City of Rancho Palos Verdes
Rancho Palos Verdes ADA Assessment
Facility Report with Photos

Facility ID: # 05 - Eastview Park

Author: Vaish, B

Location: Concrete Path
Photo # 13

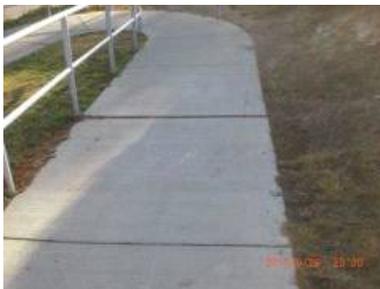
Keynote 13

Field Condition									
03B.09 - Cross Slope - Cross slope of the accessible route of travel exceeds 1:50. Existing Condition: 2.1% to 4.0% CS.

Corrective Action	
006 - Concrete Walk - Remove non-compliant pavement and replace with new concrete (area as shown on the drawings). The walkway slope shall not exceed 5% along the POT and cross slope shall not exceed 2%.	
Additional Comments:
